**A-LEVEL PLAN - ROOM NUMBERS**

**FIRST FLOOR PLAN**

**ROOM**  
 SECOND FLOOR PLAN - NUMBERS  
 PREP-102 SCALE: 1/8" = 1'-0"

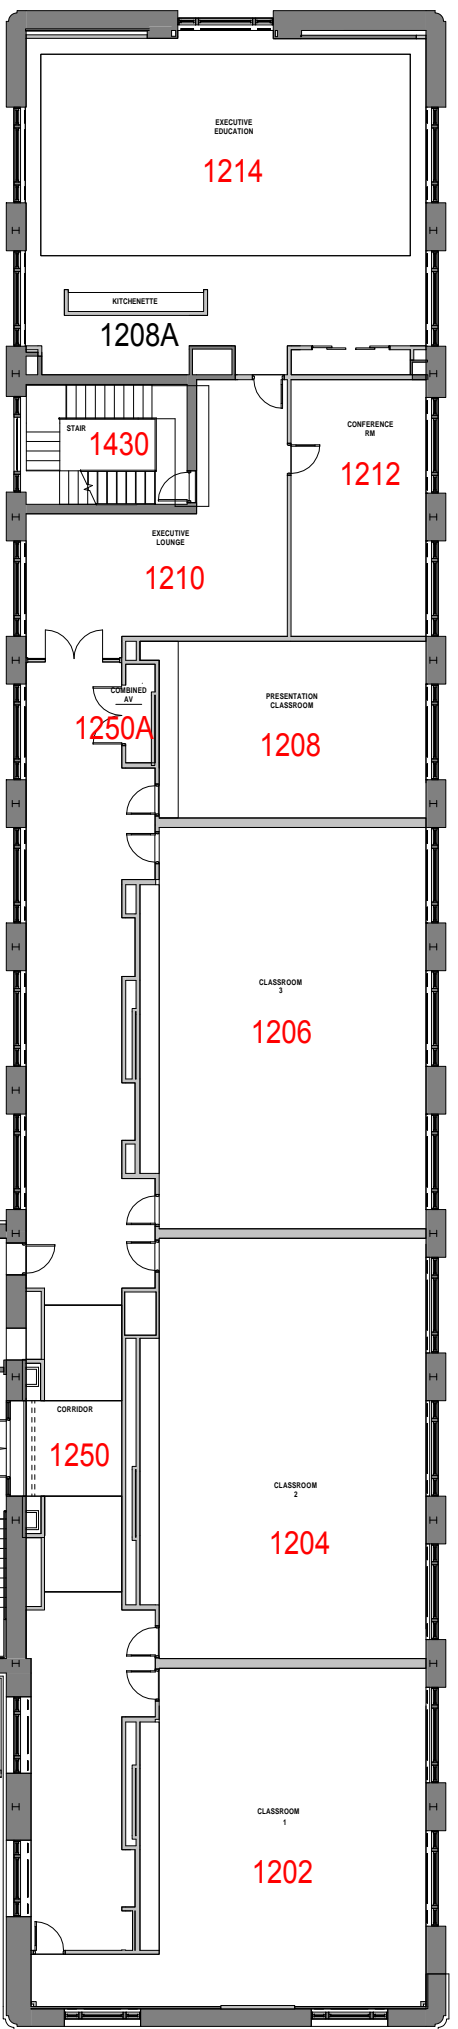
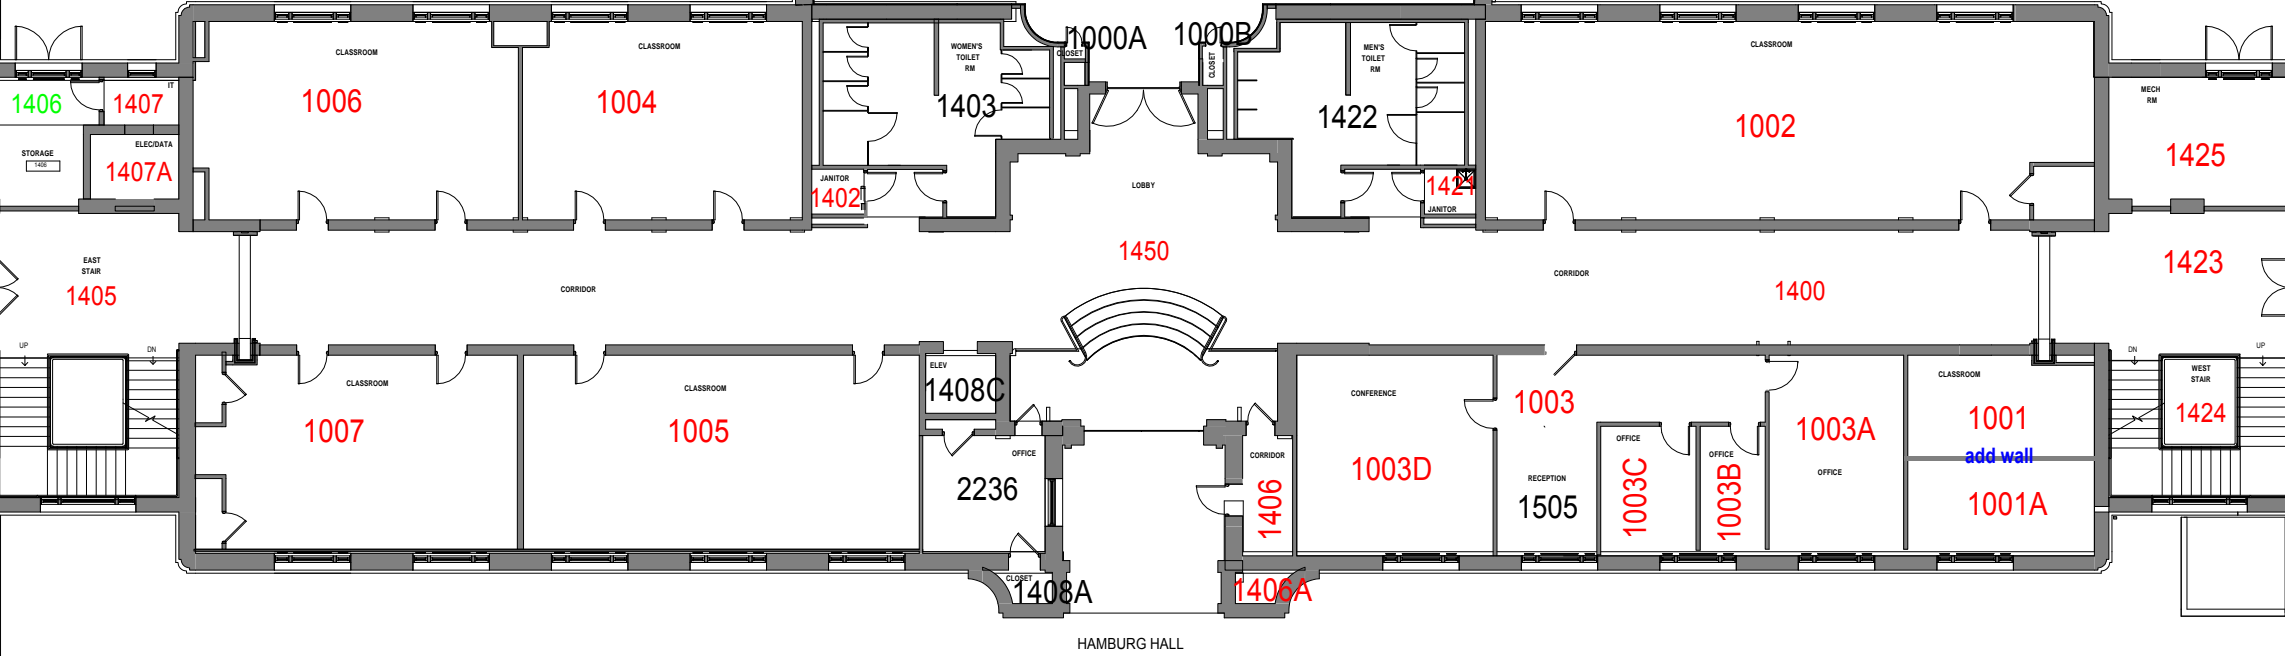
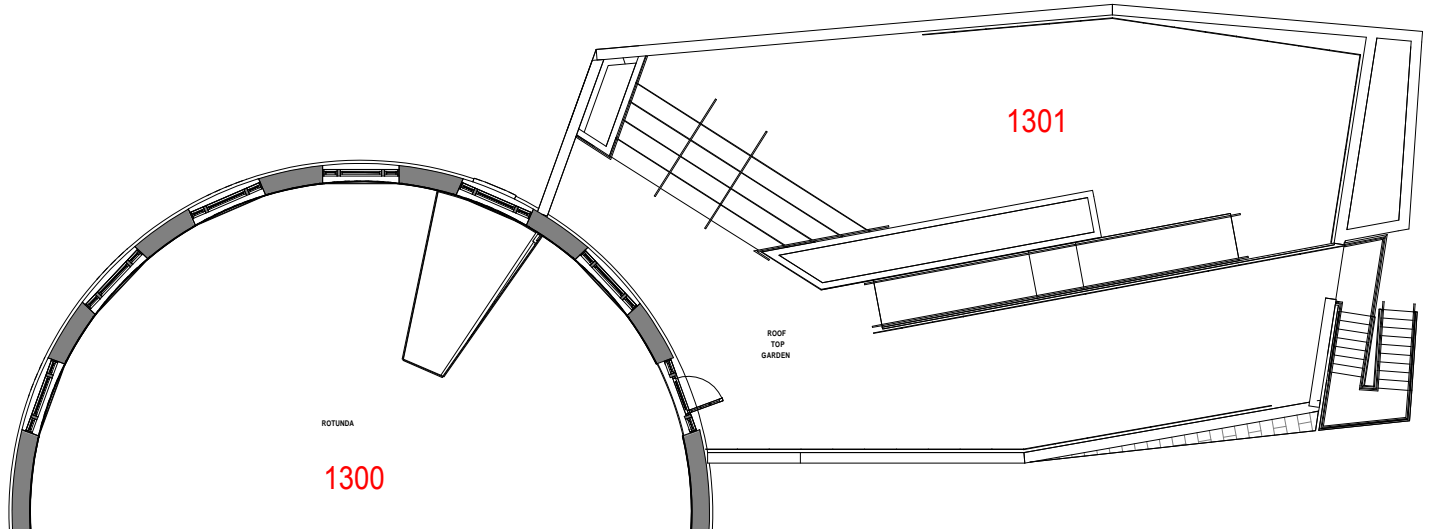
PAS Note: need door locals for rms A002D, A002E, A11A

room number clarification

PRES-101 SCALE: 1/8" = 1'-0"

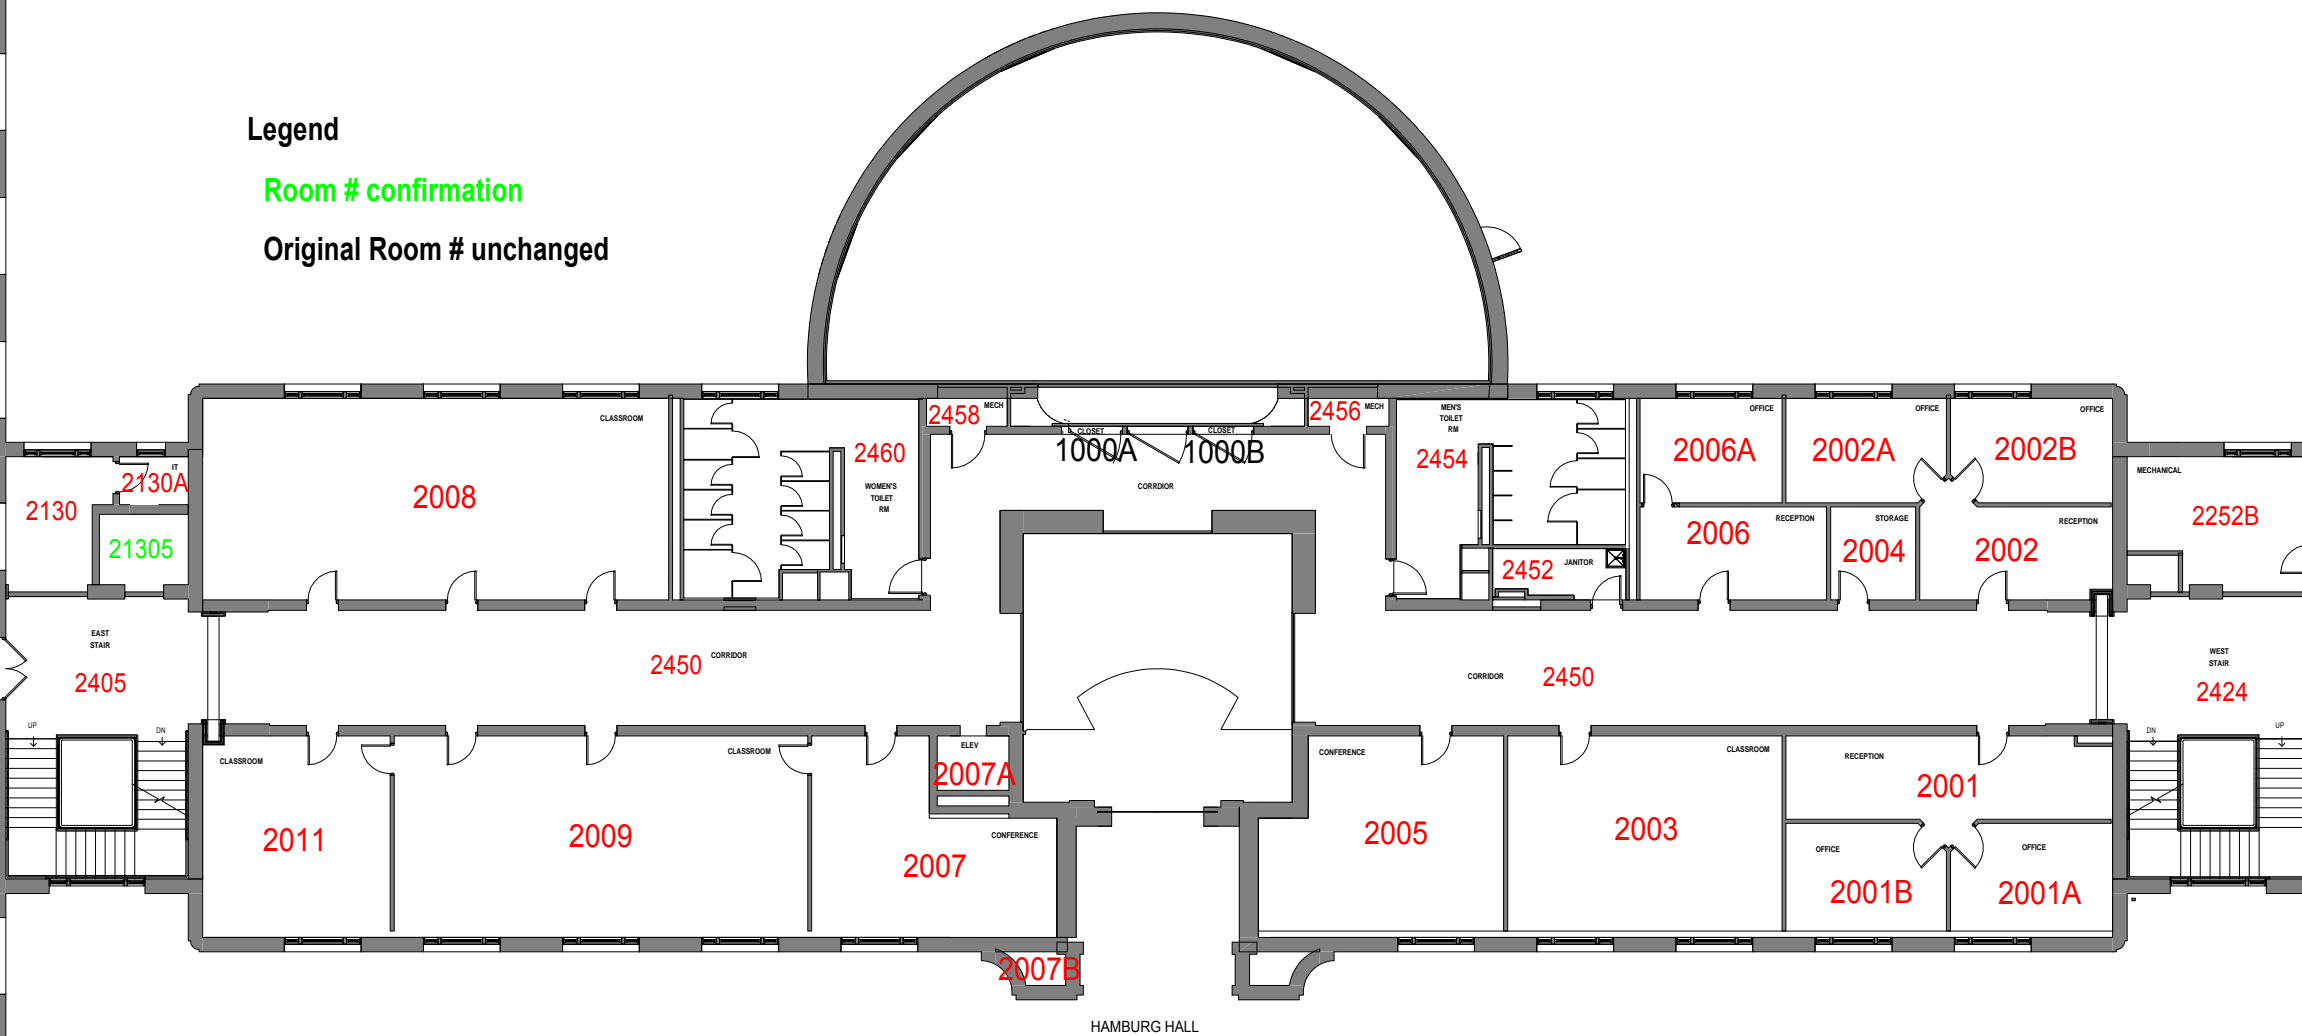
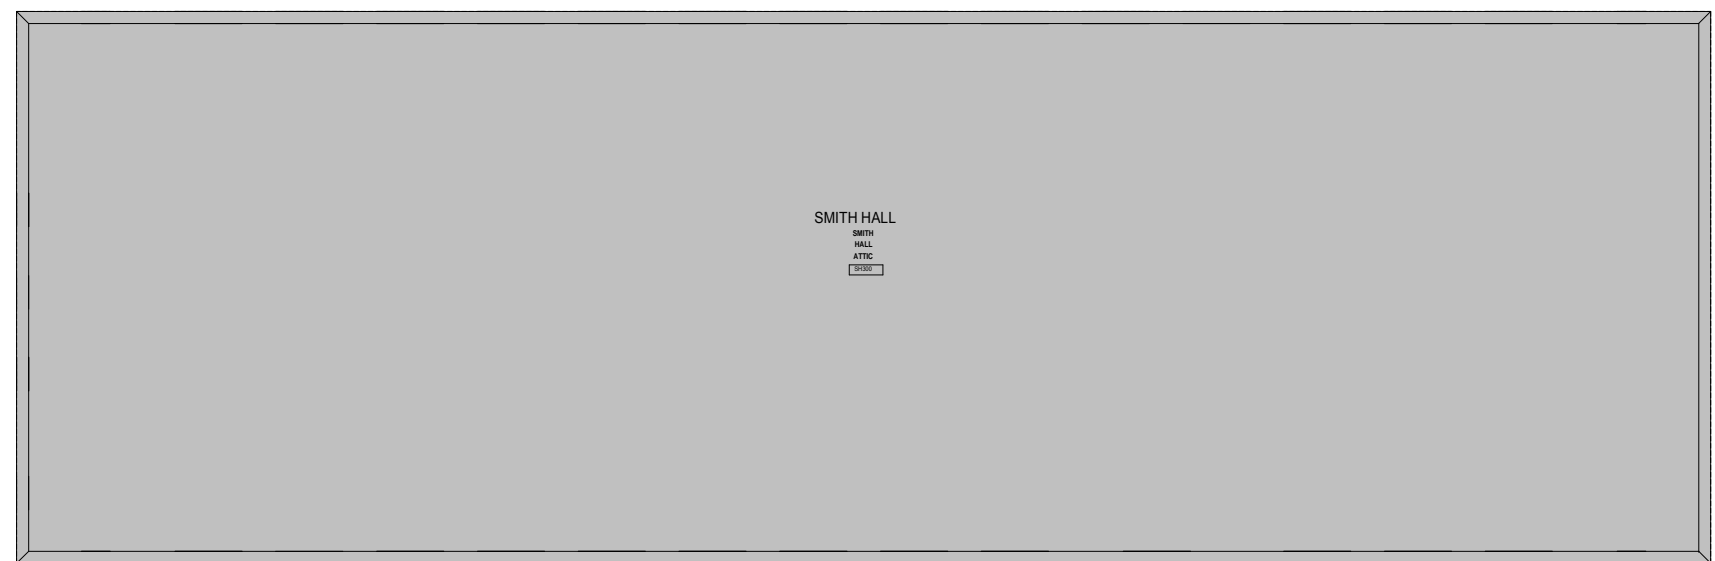
- X = remove wall
- Room # clarification
- add wall
- Original room # unchanged
